May 12, 2017

SUBJECT: Conditional Approval of Site Investigation Work Plan and Addendum for Appleton Wire (Former), 908 N. Lawe St., Appleton, Outagamie County, WI DNR BRRTS # 02-45-000015

- Figure 9, Site Plan with Proposed Additional Data Collection Points, revised 4/27/17 by EnviroForensics

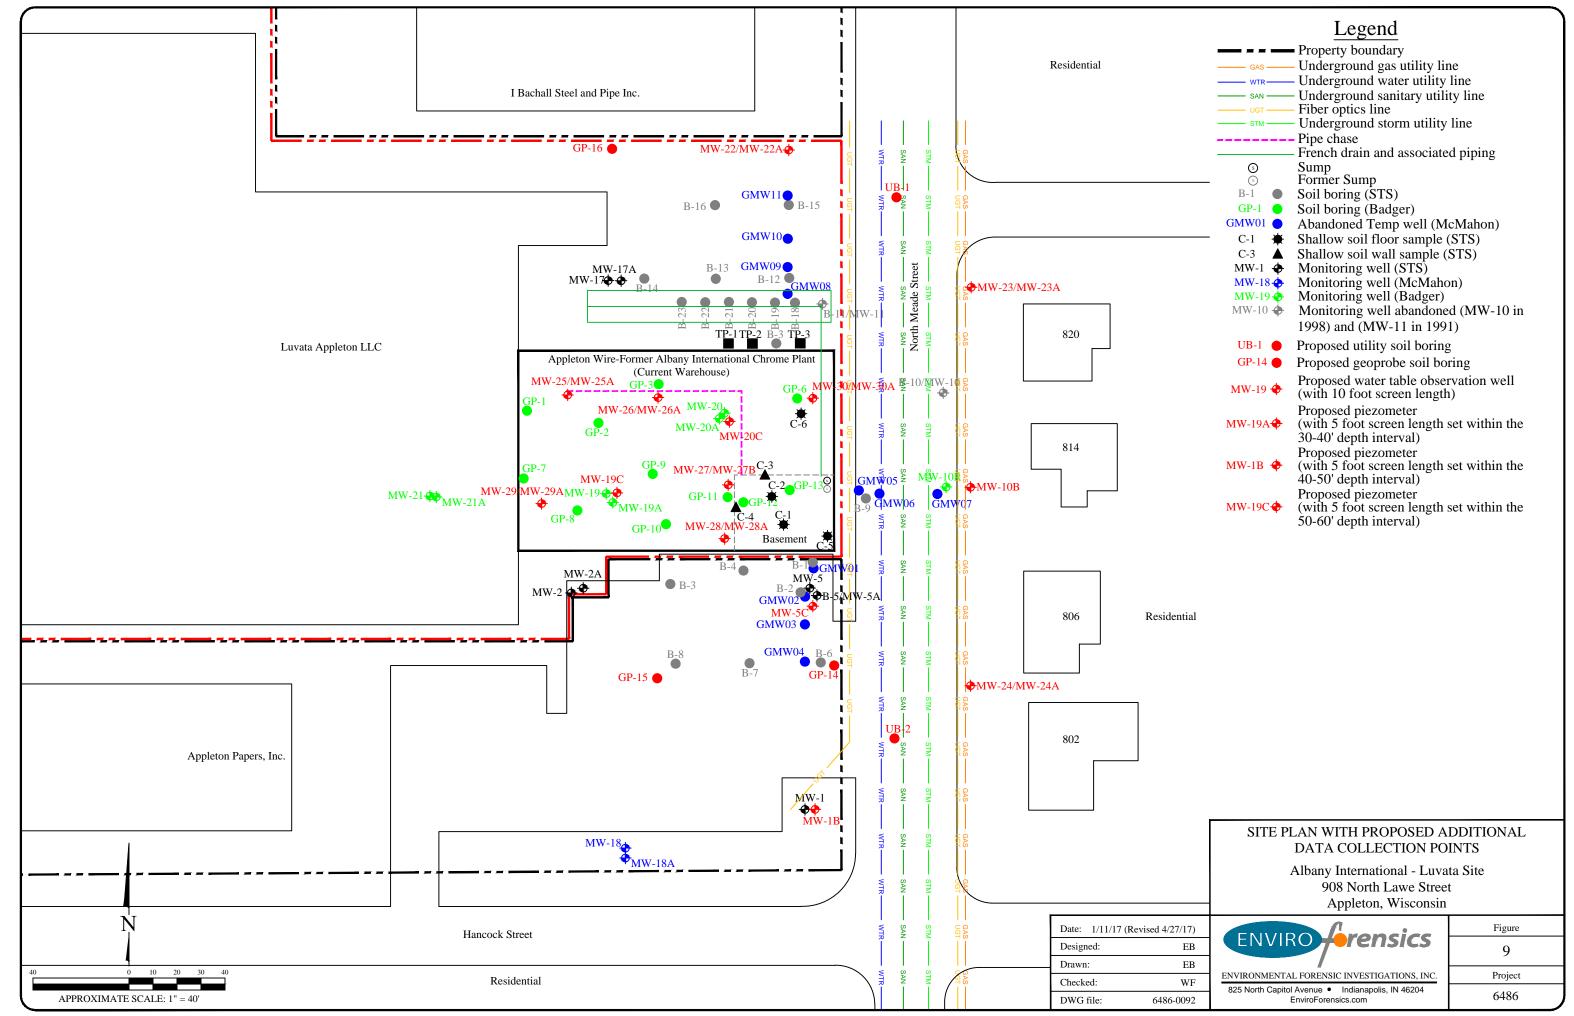
The SIWP Addendum also provided additional clarifications on the proposed supplemental investigation and revised soil and groundwater sampling locations, based on several discussions. The final proposed locations for installation of soil borings, monitoring wells and piezometers are shown on the attached Figure 9, *Site Plan with Proposed Additional Data Collection Points*, revised 4/27/17 by EnviroForensics. On May 5, 2017, the DNR provided EnviroForensics with verbal approval to proceed with drilling activities scheduled to begin on May 8, 2017.

- 4. Historical sanitary and storm sewer laterals need to be added to future site maps.
- 5. The SIWP states, "It is anticipated that the extent of chromium impacts in all Site media will have been determined to the extent practicable for remedial planning upon completion of this investigation. If that is the outcome, then a comprehensive (Site Investigation Report) will be prepared to document all past and present investigation activities following the reporting requirements of Chapter NR 716 of the Wisconsin Administrative Code." The SIWP goes on to state, "...EnviroForensics anticipates that all field work elements can be completed within three (3) months. Another two (2) months will be needed to complete the comprehensive SIR, if the results of this investigation are deemed complete."
